SERVICE BULLETIN

REPLACEMENT OF PIN PART NO. 929700 IN CARBURETOR FOR ROTAX® ENGINE TYPE 912/914 (SERIES) SB-912-048 SB-914-033

REPLACEMENT OF PIN PART NO. 929700 IN CARBURETOR FOR ROTAX® ENGINE TYPE 912/914 (SERIES) SB-912-048UL SB-914-033UL

engine
912/914

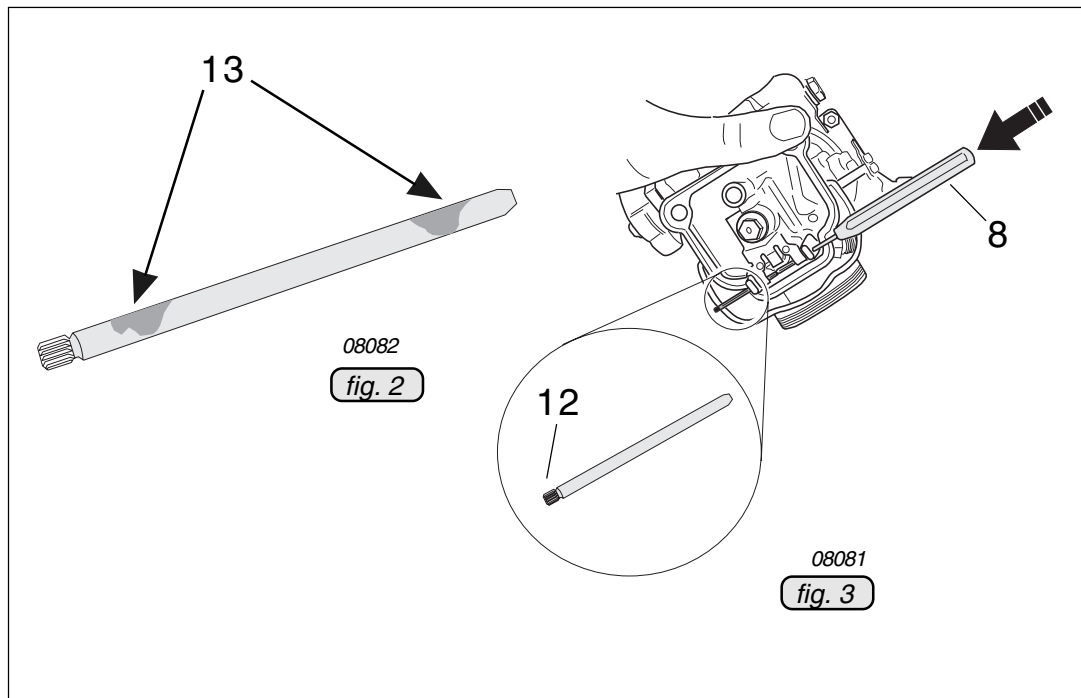
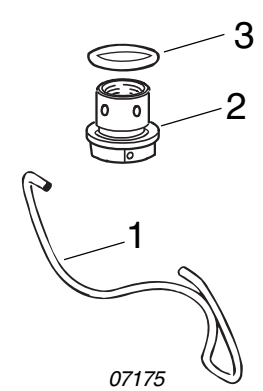
- Disconnect negative terminal of aircraft battery.
- Remove drip tray - if equipped.
- Remove carburetor.
- Open spring clip (1) or ROTAX[®] 914 (Series) open attachment screw (2) with o-ring (3).
- Remove float chamber (4) with gasket (5) and float (6).
- Remove pin (7) with appropriate pin punch (8) and remove float bracket (9) with float needle clip (10) and float needle valve (11)

◆ **NOTE:** The pin is serrated on one side (12). Put the pin punch on the opposite side and press out the pin. Don't damage the carb casting by pressing the serrated end through the pin support.

- Inspect the pin for flaking (13) of surface coating.
- Clean carburetor and fuel system, especially in case of flaking on the pin
- Check parts of carburetor.
- Install float bracket with float needle clip/float needle valve and the new pin part no. 929701
- Check if float suspension brackets are parallel and adjust if necessary.
- Install float chamber with gasket and float.
- Reassemble the carburetor.
- Install carburetor.
- Install drip tray - if equipped.
- Connect negative terminal of aircraft battery.
- perform basic throttle adjustment
